Accessibility Audit Checklist for Built Environment

- **Name of Project / Facility:** Gujarat High Court – Government Complex
- **Location:** Sola, Ahmedabad- 380060, Gujarat
- **Type of Facility:** Institutional Complex
- **Date(s) of Audit performed on site:**
 - Saturday, 20/12/2025 | Sunday, 21/12/25
 - Monday, 19/01/26
- **Date of Audit report generated:**
 - Revision - 00 : March 02, 2026

2.4 Provision for Persons with Ambulatory Impairments:

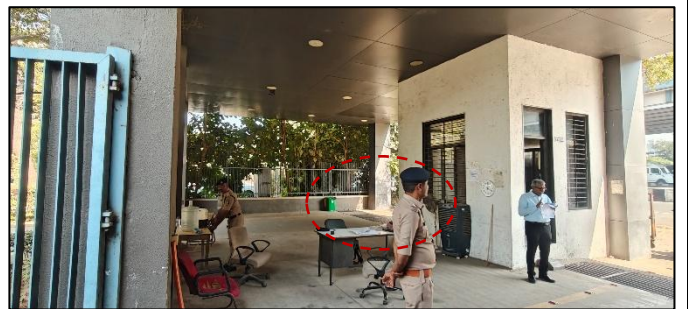
Wheelchair provision should be available at the entry gate to assist persons with ambulatory impairments, elderly persons, and pregnant women. A minimum stock of 8–10 wheelchairs with designated storage space, waiting seating, and clear signage indicating availability is required, considering the scale of the campus.

Currently, an electric cart service is available on call; however, no designated parking, pick-up, or drop-off locations are provided, and transfers currently occur on the main driveway. A dedicated cart station with clear signage and a location map should be provided, preferably on the north side inside Gate 5 where adequate space exists.

Pick-up and drop-off points should be designated across the campus and clearly indicated on visible maps installed at these locations and at major building entrances. A site-level mobility plan should define routes and designated stopping points for different user groups. This would significantly improve accessibility across the large campus, where long travel distances make independent movement difficult for persons with disabilities, elderly persons, and pregnant women.

6.11 Lighting and Visual Contrast

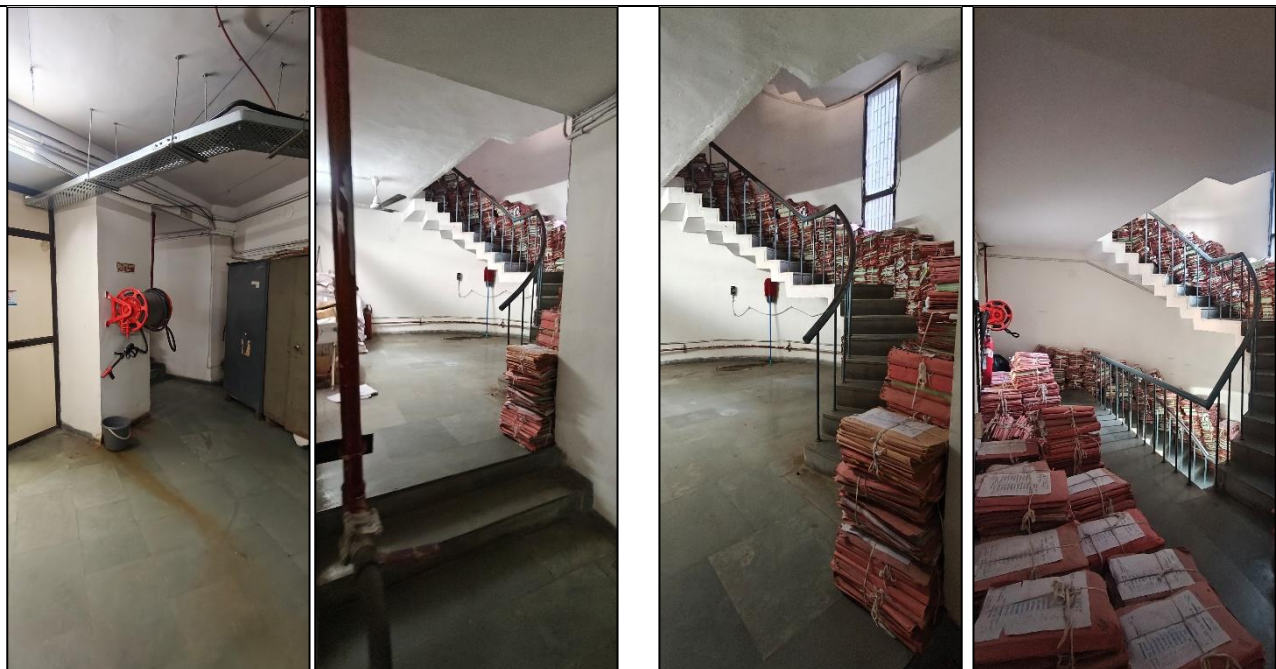
The staircase areas are inadequately lit and rely almost entirely on artificial lighting. The illumination levels are insufficient for safe movement and do not comply with recommended standards for circulation and egress routes. There is no visual contrast provided at step edges or nosing, which further reduces safety for persons with low vision. The combination of poor lighting and absence of visual contrast makes manoeuvring difficult and increases the likelihood of accidents.

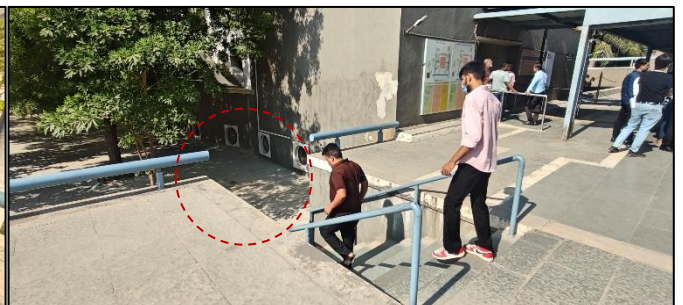
1.5 Alternative Vertical Access: Elevators provide the only practical accessible vertical circulation from the first-floor entrances to the upper and lower floors of the Main Court Building. While the elevators allow movement between levels, dependence on elevators alone does not provide a reliable accessible circulation system, particularly during emergency situations. The elevator entrances have approximately a 25 mm (1 inch) threshold, which is not accessible for wheelchair users and presents a tripping hazard for persons with vision impairment. This can be rectified with minor modifications.

Alternative access through internal staircases is not conveniently located near the main entrances, and require additional travel distances of approximately 50 meters or more. Most staircases are positioned along the exterior façade, exposed to weather conditions. These staircases do not comply with accessibility requirements, reducing usability and creating significant difficulty, particularly during emergency evacuation when elevators cannot be used.

At the first-floor level, the elevated corridors terminate at the central courtyard through a staircase connection. At this junction, the platform edge is protected only by a low parapet wall of approximately 300 mm height. This does not comply with accessibility requirements or the provisions of the National Building Code for guardrail safety. The condition presents a serious safety hazard, particularly for persons with blindness or low vision, as well as for general users.

No tactile warning blocks are provided at these exposed edges to alert persons with vision impairment of the sudden drop. Similar conditions were observed along multiple stretches of the elevated corridors where adequate guardrails are not provided. The absence of compliant guardrails and tactile warnings creates a high risk of accidental falls and represents a critical safety concern under both accessibility standards and National Building Code requirements.

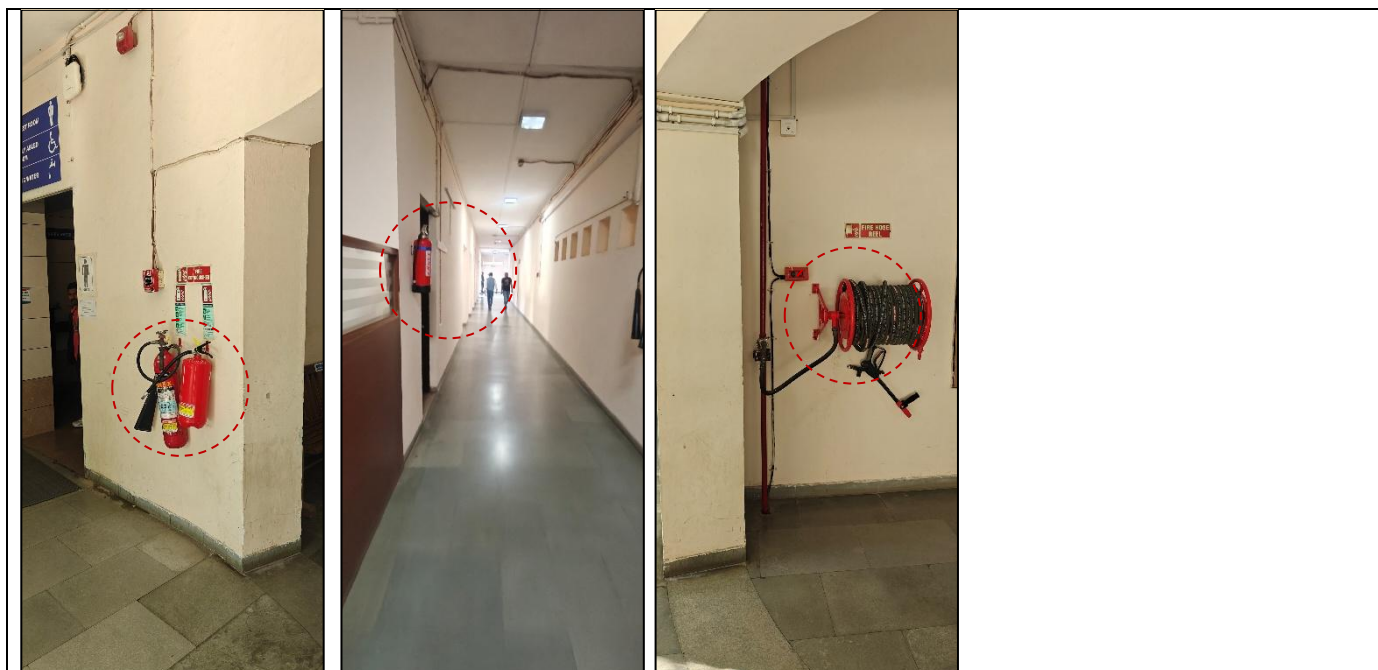
4.1 Corridors and Obstructions: At the ground floor, the peripheral corridors are generally free of obstacles and allow wheelchair accessibility. Minor barriers exist for persons with visual impairment due to fire hydrants mounted along the corridor walls below 2000 mm height. In the lobby areas outside the court chambers at each floor level and in the basement, fire hydrants and fire hose reels are mounted along the walls and project into the circulation space. The hose reels project approximately 400 mm from the wall at a height of about 1200 mm, creating a significant barrier and hazard for persons with visual impairment and low vision. Recommendation: At the ground and first floors, this issue can be resolved by relocating fire hydrants into recessed wall niches or to opposite walls where adequate depth is available, so that the equipment remains visible without protruding into the circulation space. Similar treatment is recommended at all floors and basement levels. Fire hose reels should be mounted with a protective frame extending to floor level so that they fall within the cane-detection range, allowing persons with visual impairment and low vision to detect and navigate safely. 4.2 Corridor Width and Manoeuvring: Corridor widths are sufficient for wheelchair movement. However, improved lighting levels are required, particularly at the ground floor, to support safe movement for persons with low vision. 4.3 Floor Finish: Floor finishes are firm, even, non-slip, and suitable for mobility aids. 4.4 Level Changes and Hazard Marking: Minor level projections and changes in level are present along circulation routes. These are not marked with tactile warning blocks or contrasting colour bands. Installation of tactile warning indicators and visual contrast markings is required for persons with visual impairment and low vision. Third Floor Bridge: Peripheral corridors are provided at all levels. At the third (top) floor, an arched steel bridge connects the corridors of all four wings and forms part of the internal circulation system. The arched bridge does not comply with accessibility requirements. The gradient exceeds the maximum permissible slope of 1:12 for accessible routes, making it unsuitable for wheelchair users and persons using crutches or other mobility aids. Due to the excessive slope, this connecting route is not accessible to persons with mobility and ambulatory impairments. As a result, continuous accessible connectivity between the four wings at the third-floor level is not achieved. This condition requires corrective intervention to ensure compliance and uninterrupted accessible circulation.

7.4 Internal Car Dimensions: Elevator car dimensions appear adequate for wheelchair manoeuvring and generally comply with the minimum space requirements.

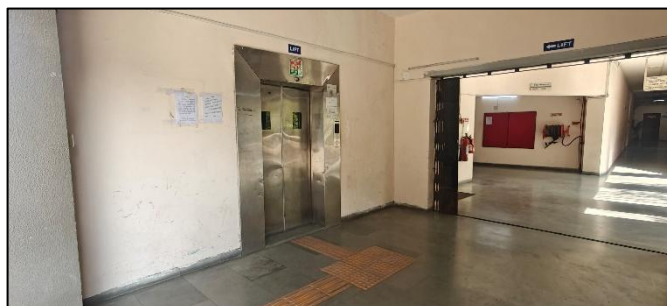
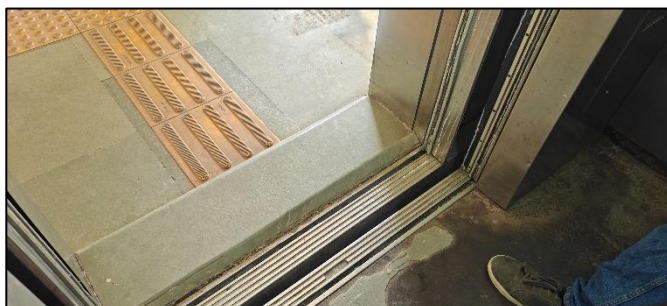
7.3 Step-Free Access and Thresholds: A step-free path is available to the elevators; however, elevator entrances have sharp thresholds of approximately 25–30 mm. These thresholds act as barriers for wheelchair users and present a tripping hazard for persons with visual impairment. Threshold modifications can be carried out with minor intervention to achieve compliance.

7.5 Lift Controls Height: External lift control panels are accessible in terms of approach and usability; however, the mounting height does not fully comply with accessibility requirements for wheelchair users.

9.00: Circulation- Ramp (s) Design Compliance:

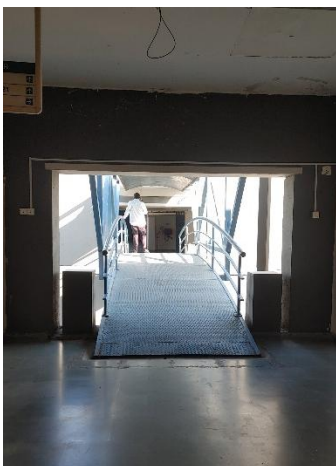
No ramps are provided as part of the internal vertical circulation within the Main Court Building. Vertical movement for persons with disabilities is dependent entirely on elevators.

4.2 Corridor Width and Manoeuvring: Corridor widths on both floors are sufficient for wheelchair movement and passing. Turning spaces at intersections and lobby areas are generally adequate.

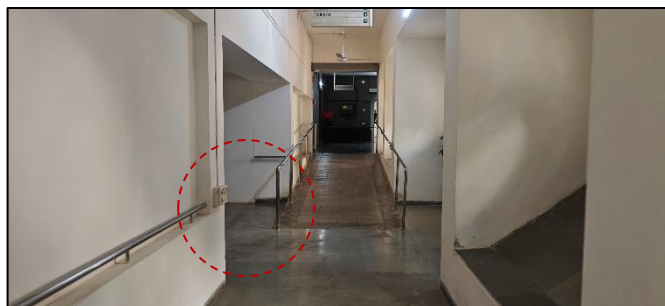
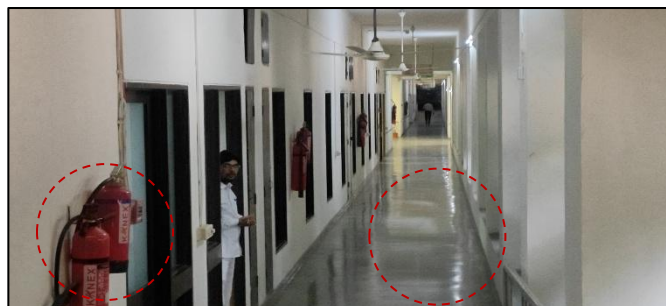
At the first floor bridge connection to the Main Court building, the ramp and 4–5 steps are not provided with tactile warning indicators, creating a hazard for persons with visual impairment and low vision.

However, lighting levels—particularly at ground floor—are insufficient and require improvement to support safe navigation for persons with low vision.

1.3 Provision of Ramps: The shared entrance plinth level is approximately 400 mm below the main driveway level, and access is provided through ramp and steps both.

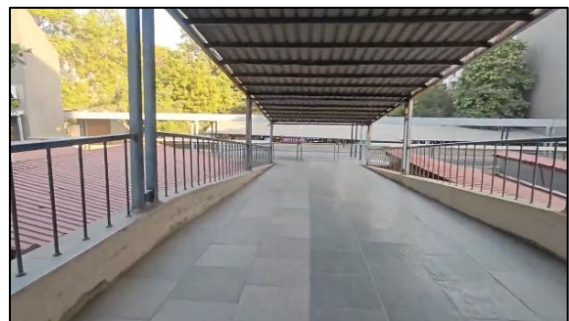
The ramp partially complies with accessibility requirements. A clear top landing of minimum 1800 mm (72 inches) is required; however, the ramp terminates directly into the pathway, which does not meet code requirements for a safe maneuvering landing. A level landing should be provided before the ramp descent to allow wheelchair users to safely position and control movement, to enable persons with visual impairments to orient themselves, and to ensure a safe transition area for other users and service trolleys without directly entering vehicular circulation.

1.4 Ramp Compliance: This ramp is used by able-bodied users, persons with disabilities, and service movement including file and goods trolleys with associated loading and unloading activities. It is also expected to function as part of the emergency and fire egress route.

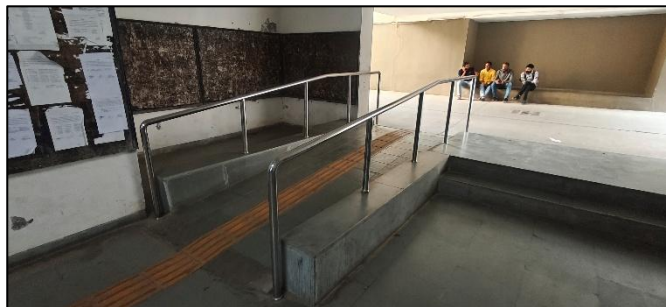
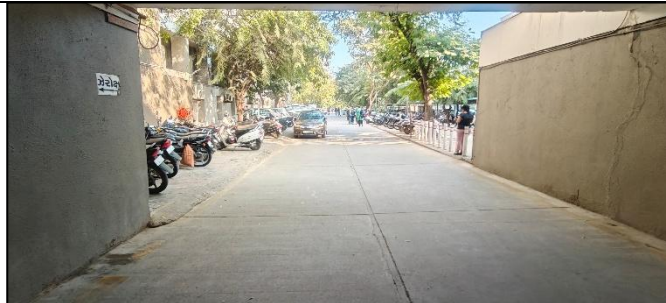
The ramp partially complies with accessibility requirements. A clear top landing of minimum 1800 mm (72 inches) is required; however, the ramp terminates directly into the driveway, which does not meet code requirements for a safe manoeuvring landing. A level landing is required before descending the ramp to allow wheelchair users to safely position and control movement, to enable persons with visual impairment to orient themselves, and to provide a safe transition area for able-bodied users and service trolleys without entering directly into vehicular movement.

It is recommended that the ramp be extended by approximately 2000 mm to provide a compliant landing area.

6.12 Provision of Fire Staircases

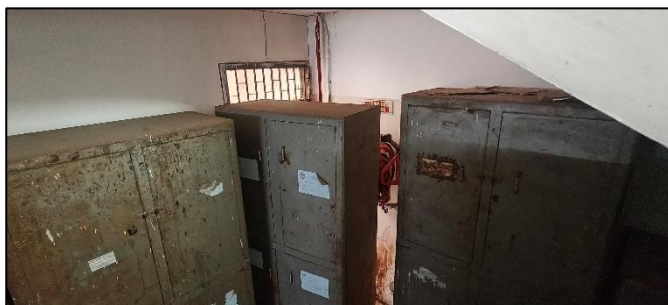
Fire staircases are required based on the building height, occupancy load, and use. However, the existing staircases require detailed technical evaluation to determine compliance with fire safety and emergency egress requirements.

The staircases in both wings do not comply with fire safety or accessibility requirements. The staircase areas are heavily encroached upon and are being used as storage spaces. Files, storage units, and other materials are placed along the staircase flights, landings, and approach passages. In several locations, the staircases are partially obstructed and are not functional for regular circulation.
